BZA 21404
5034 Nebraska
Avenue, NW
(Sq 1879, Lot 0030)

Presentation by
Guillermo Rueda, AIA

Board of Zoning Adjustment
District of Columbia
CASE NO. 21404
EXHIBIT NO. 52

Plat Errors

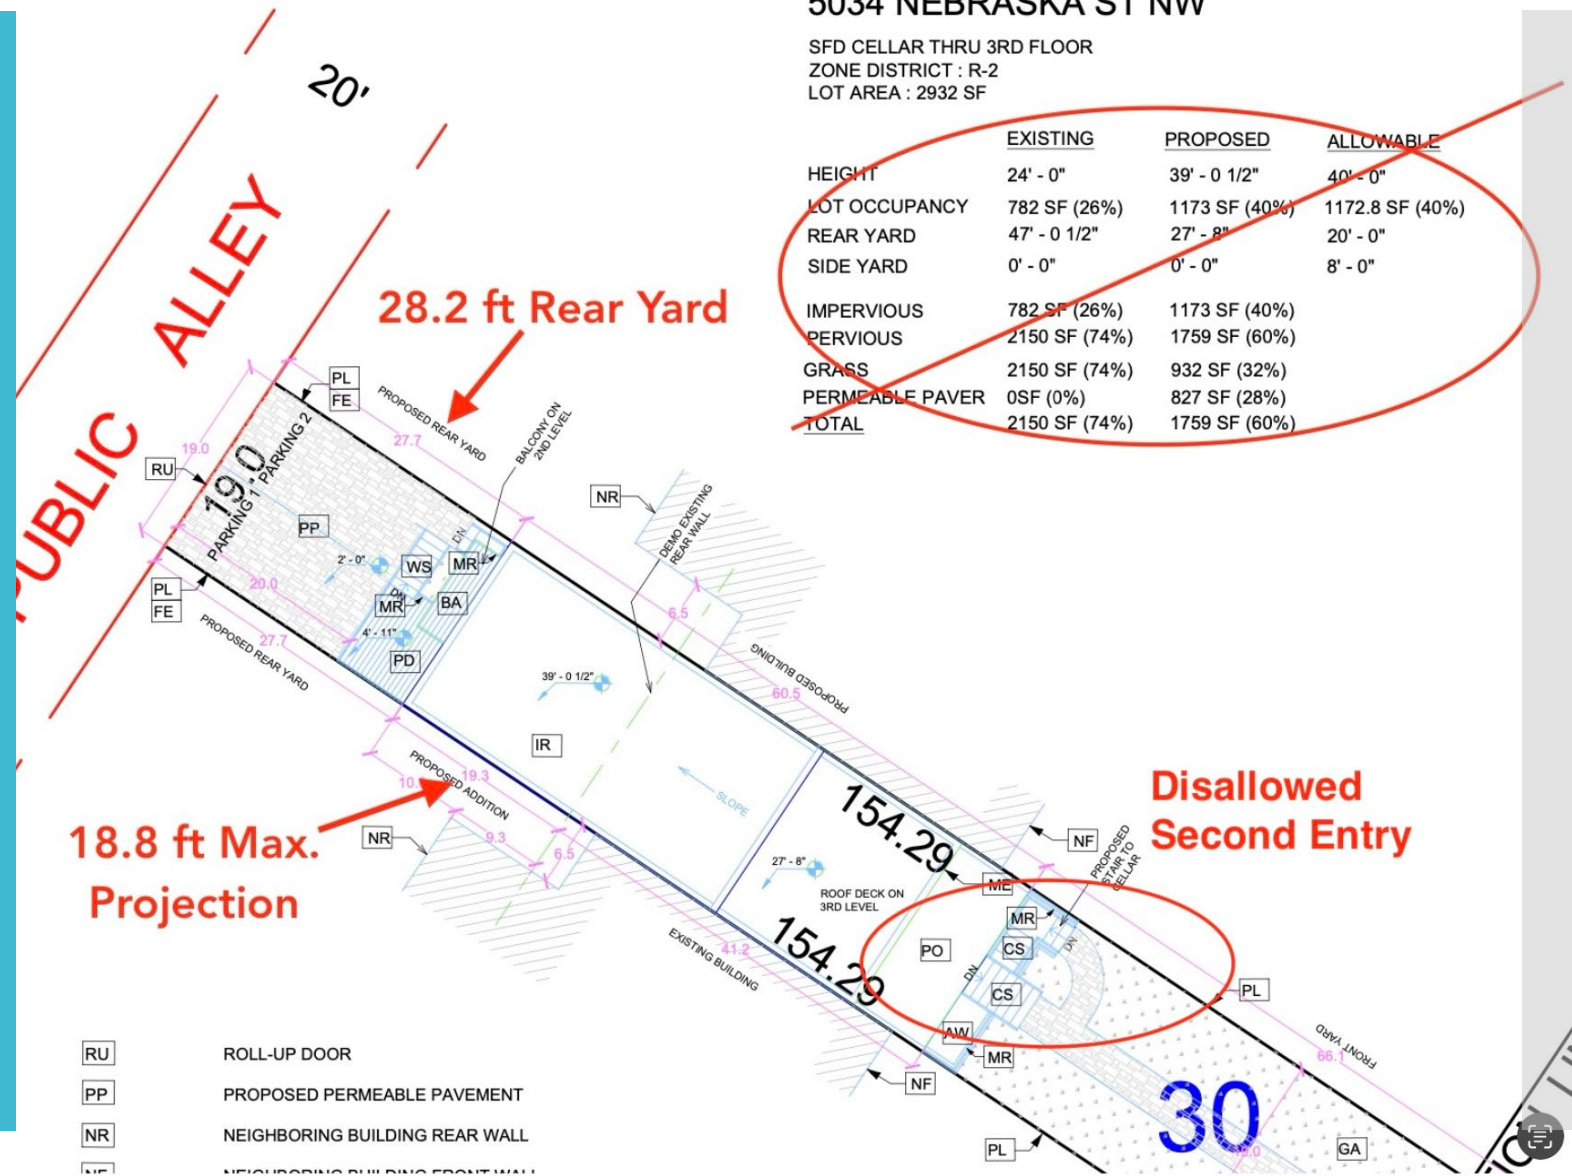
- The application contains numerous inaccuracies and omissions.
- The self-certification fails to identify existing nonconformities.
- Submitted drawings contain dimensional inconsistencies that affect zoning compliance.
- Questions also exist regarding the professional certification included with the application.

Figure 2 — Same view with proposed addition per plans as filed (Exhibit 28A), September 22, 5:00 PM.

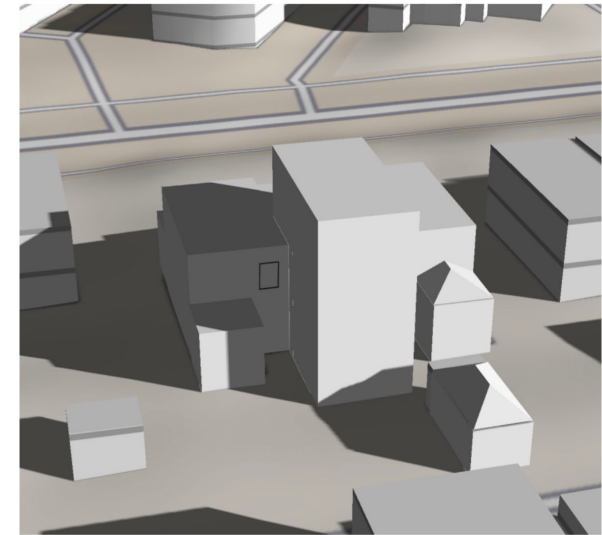
Applicant Ignores the
5036 Solar Energy
System

- The Solar Energy System at 5034 has been in operation since 2008 and meets the criteria of the regulations.
- The Applicant's shadow study fails to model the proposed new row building or analyze its mass and impact on light and air construction.
- Applicant's revised shadow study does not measure the impact on Solar Energy System.
- Based on analysis of the evidence presented, the project will likely exceed the allowable solar shading threshold of 5%.

Figure 2-2. Comparison of proposed relief to current plans as filed (Exhibit 28A), September 22, 5:00 PM.

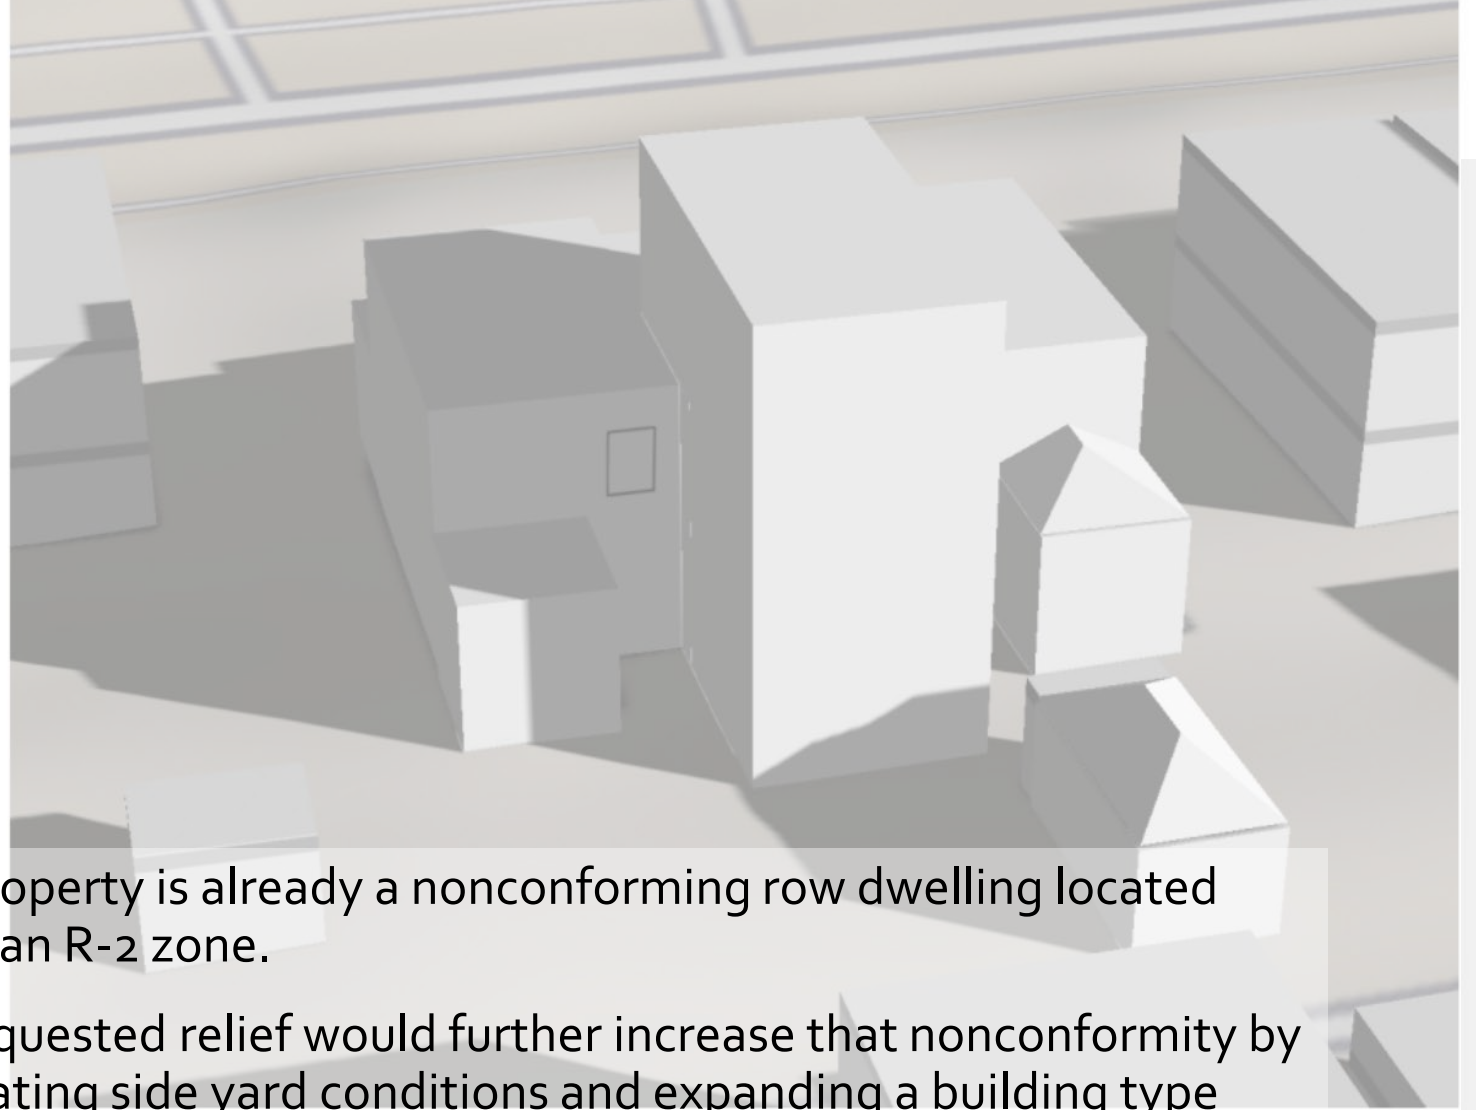
- This property is already a nonconforming row dwelling located within an R-2 zone.
- The requested relief would further increase that nonconformity by eliminating side yard conditions and expanding a building type that is not permitted in the R-2 District.
- The regulations were intended to limit—not intensify—these existing nonconformities.

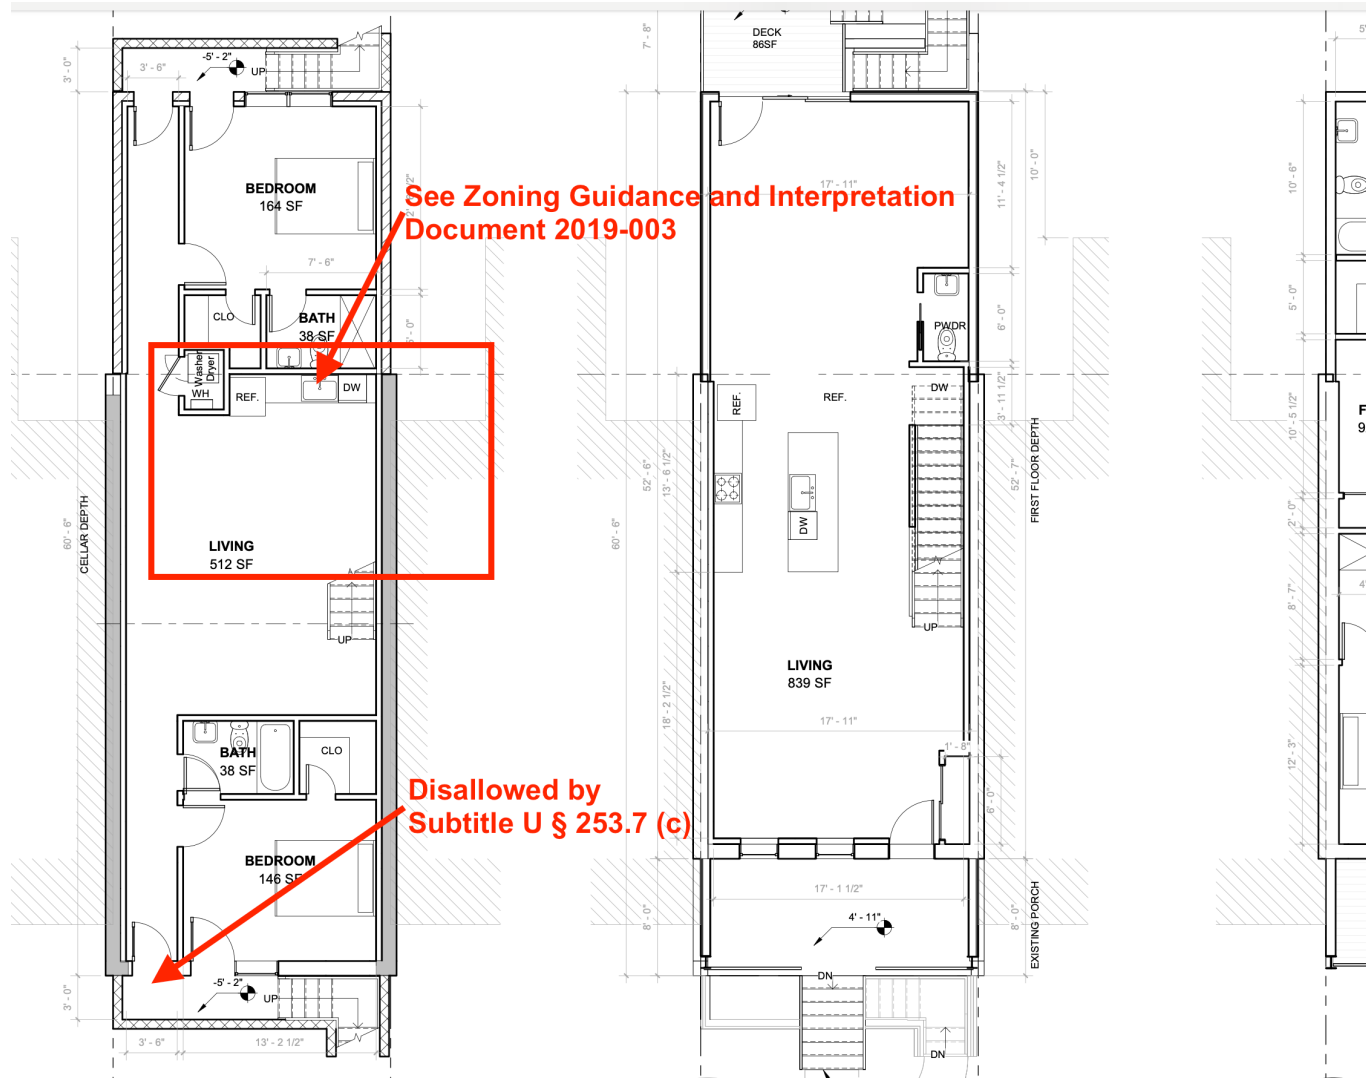
- The R-2 zone is intended to preserve low-density neighborhoods consisting primarily of detached and semi-detached homes. Subtitle D § 101.7.
- The R-2 zone disallows the row building type—the proposed construction is a larger row building than exists.
- The purpose of the R-2 zone is to “Protect these areas from invasion by denser types of residential development.” Subtitle D § 101.6.
- The proposal significantly increases building mass, height, and density in a manner more characteristic of the R-3 district.
- Granting this relief would undermine the purpose and intent of the adopted zoning plan.

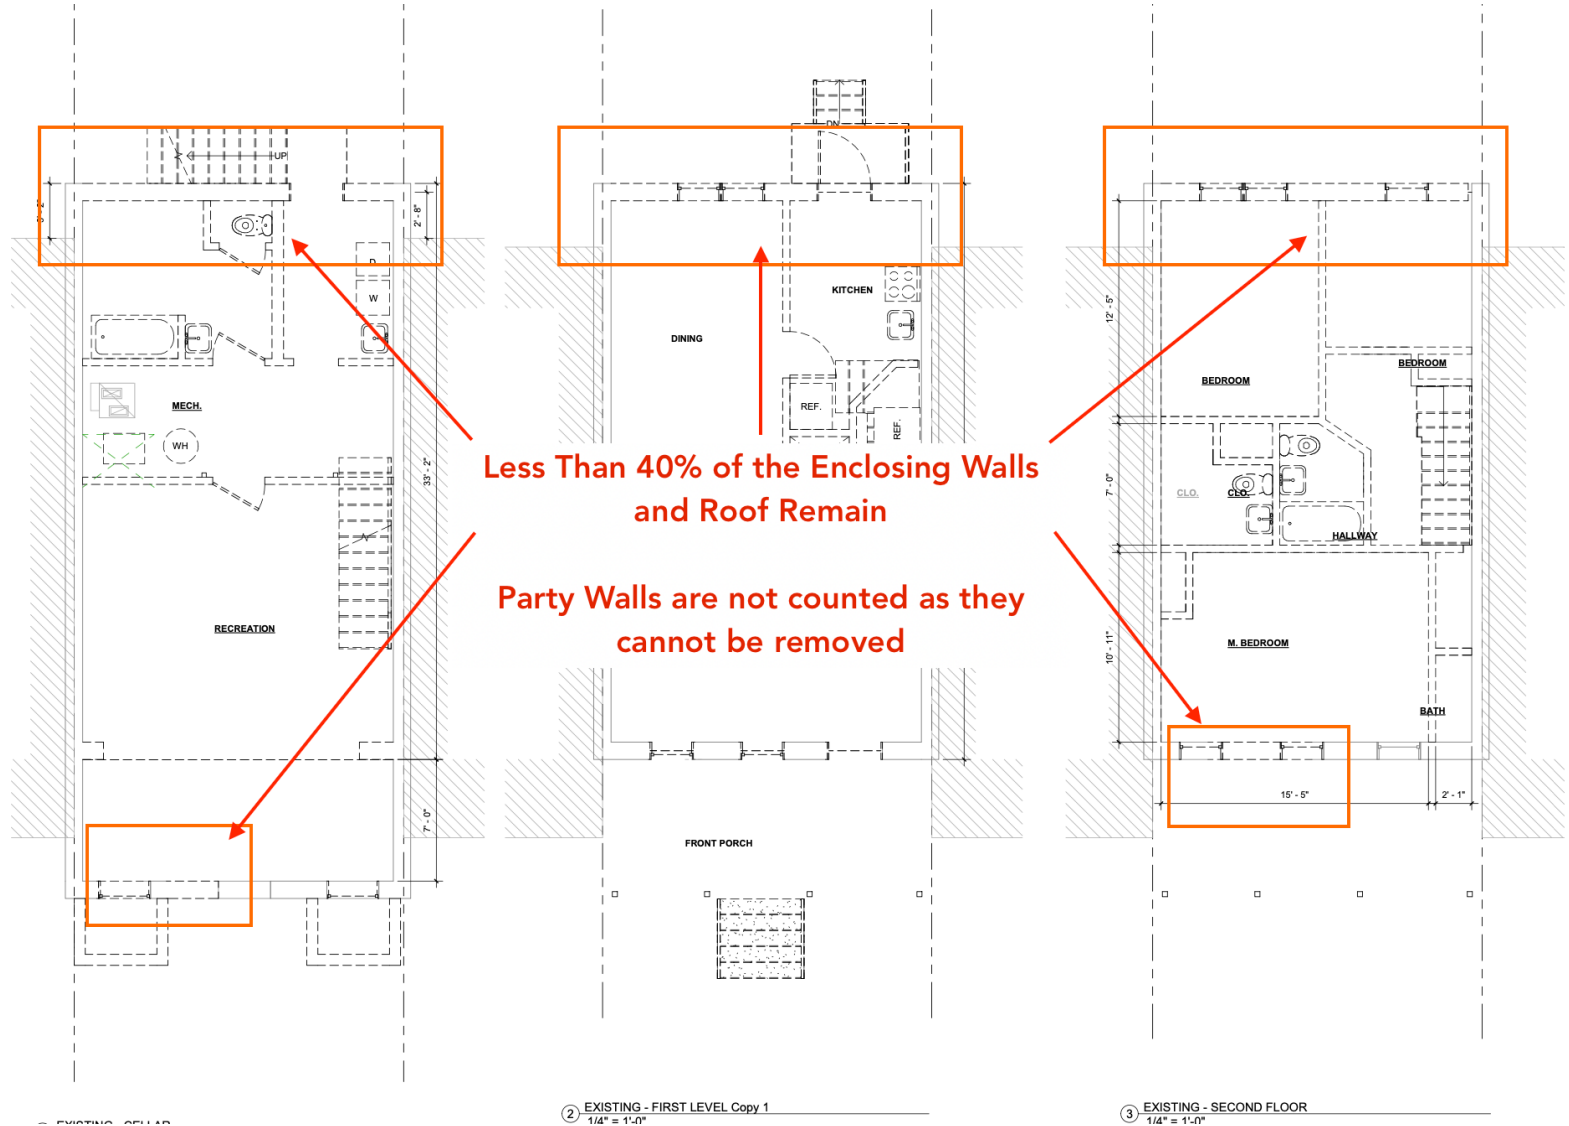
The extent of demolition exceeds what would typically be considered a partial demolition.

Under ZA Interpretation #10, the project likely constitutes a zoning raze.

If so, the structure would lose its existing nonconforming rights and be evaluated as a new building required to comply with current R-2 standards.

An expansion of the Row Building in either case cannot be permitted.
